COUNCIL ASSESSMENT REPORT

Panel Reference	PPSSEC-30
DA Number	477/2019/1
LGA	Woollahra Municipal Council
Proposed Development	First stage of the development of White City including multi-purpose sporting facilities and registered club facilities and site remediation
Street Address	30 Alma Street Paddington
Applicant/Owner	Hakoah Club Limited & Sydney Maccabi Tennis Club Ltd
Date of DA lodgement	6 December 2019
Number of Submissions	289
Recommendation	Conditional Approval
Regional Development Criteria (Schedule 7 of the SEPP (State and Regional Development) 2011	Development with a capital investment value exceeding \$30million.
List of all relevant s4.15(1)(a) matters	<ol style="list-style-type: none"> 1. State Environmental Planning Policy (State and Regional Development) 2011 2. State Environmental Policy No. 55 Remediation of Land 3. Sydney Regional Environmental Plan (Sydney Harbour Catchment (2005) 4. State Environmental Planning Policy (Infrastructure) 2007 5. Woollahra Local Environmental Plan 2014 6. Woollahra Development Control Plan 2015

SYDNEY EASTERN CITY PLANNING PANEL DEVELOPMENT APPLICATION ASSESSMENT REPORT

FILE No.	DA 477/2019/1
ADDRESS	30 Alma Street PADDINGTON

The image above shows the Club building's setback from the southern boundary to Sydney Grammar in the proposed development – equating to 12.75m.

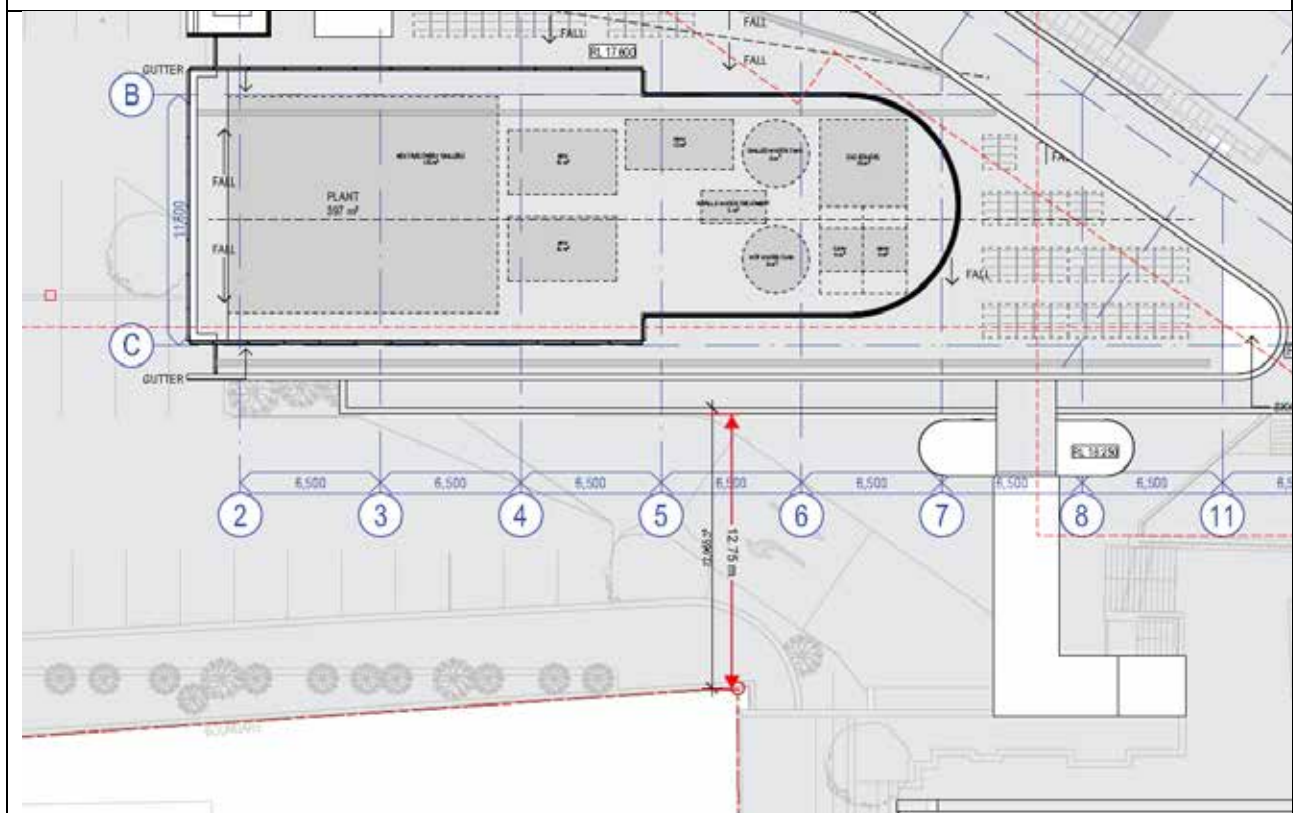
The proposed Club building has a setback of approximately 12.75m from the site’s southern boundary with Sydney Grammar School. This constitutes a reduction of approximately 3.25m, when compared to the approved concept development, as shown in the image below:

It is not considered that the minor reduction in building setbacks would render the proposal inconsistent with the approved concept development (Refer to Section 6.1.3).

Figure 7 - Sports noise assessment grid noise map showing the weekly worst case noise scenario shown as LAeq over 15 minutes from Page 38 of the Acoustic Assessment Report

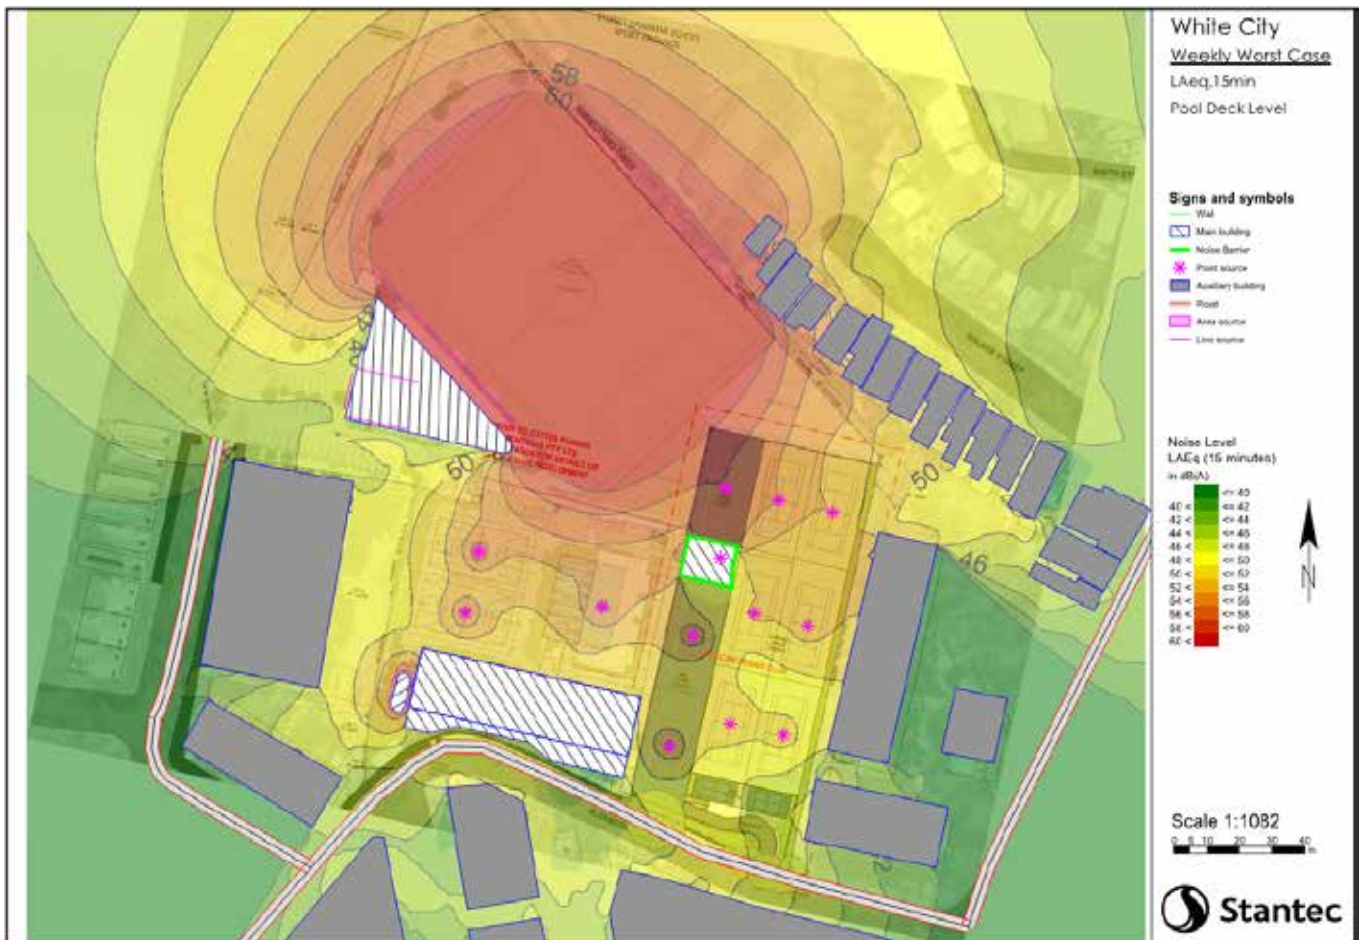
The map below shows the acoustic LAeq impact on the site as a result of the proposed development. It is evident that the most significant generator of noise is the football field, which would most severely affect properties at 24 – 12 Walker Avenue.

It is reasonable to expect an increased level of noise to surrounding properties, due to the intensification of use on the site, and the replacement of tennis courts with a football field, which is a sport that generates a greater acoustic impact due to the nature of the game, the number of players on the field, and the potential for spectators to generate noise.

Figure 8 - The image above, taken from the light spill assessment report, shows that the proposal would result in minimal light spill to adjoining properties.

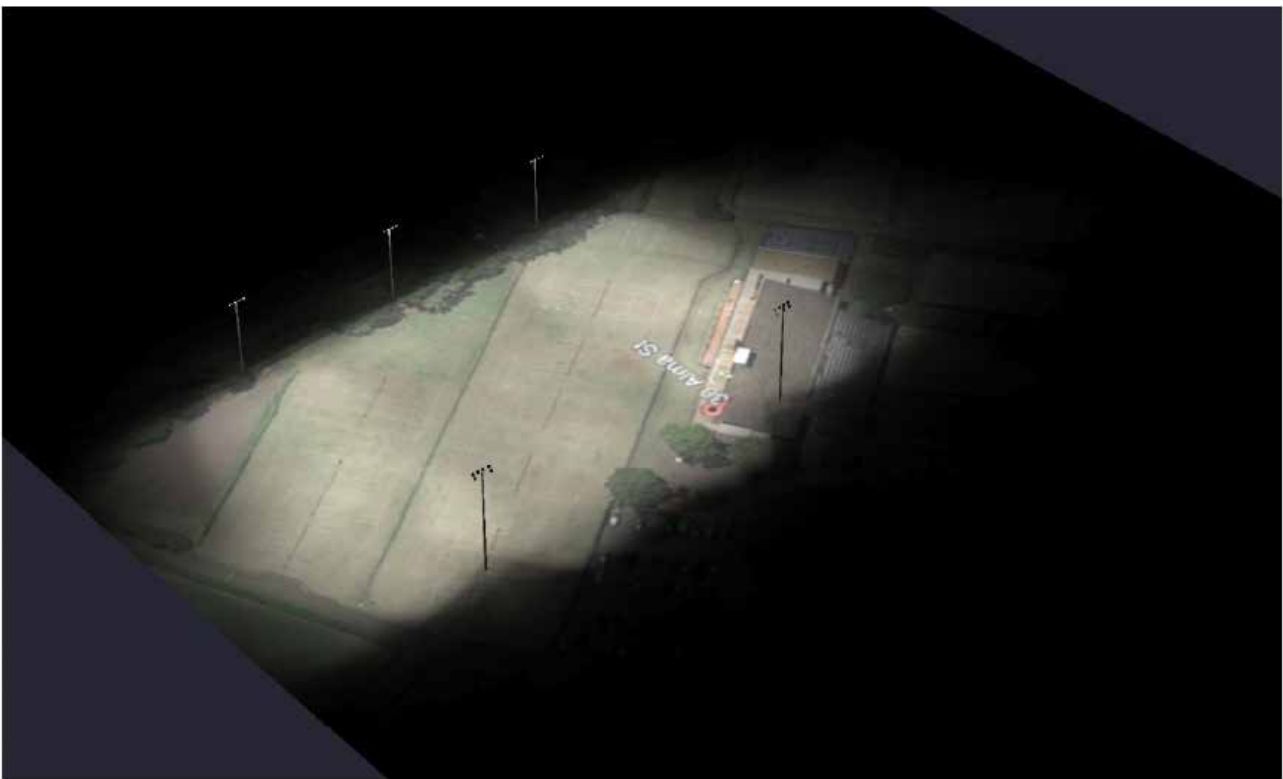
The plans provided with the light assessment report for the football field indicate that the light spill to residential properties at Walker Avenue would be approximately 10 lx adjacent to the site boundary. It is noted that the light assessment report has not accounted for the mitigating effect of landscaping along the boundary of the subject site. Figure 8 below shows the proposed lighting design for the football field, overlaid onto aerial photos, indicating that the proposed football field lighting would not result in significant light spill to nearby residential properties.

Figure 9 - Proposed route of construction vehicles as included in the Response to SOFAC Traffic Report prepared by Ason Group dated 4 August 2020

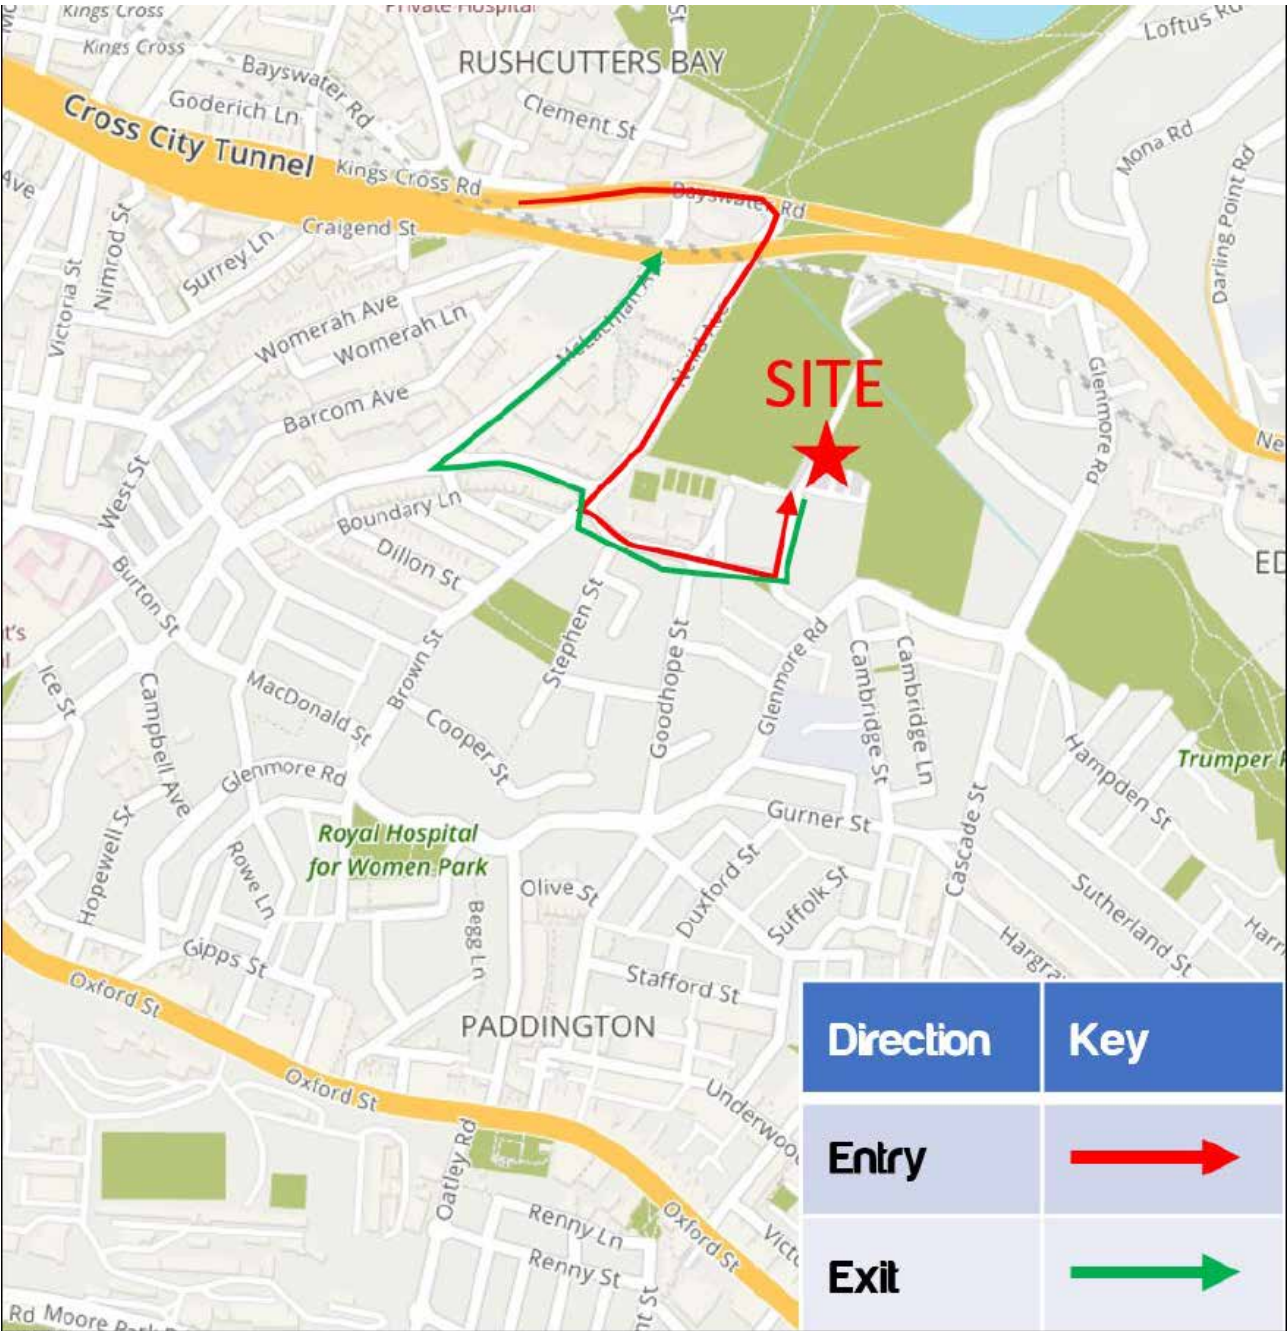
no longer seeks to route construction vehicles through the local residential streets of Paddington. Instead, construction vehicles will approach the site from New South Head Road via Neild Avenue, and exit the site using MacLachlan Avenue and New South Head Road. The amended construction vehicle route is supported, as it comprises the most direct route to and from New South Head Road to the site, which will minimise the impact of construction traffic on local residential streets. The amended construction vehicle route is shown in Figure 9 below:

Condition D.6 is recommended which would limit medium rigid vehicle and heavy rigid vehicle movements to the site during the school drop-off and pick up period (7.30am – 9.30am and 2.30pm – 4.30pm). In conjunction with traffic controllers, it is considered that this condition will greatly mitigate the risk to pedestrians within Alma Street.
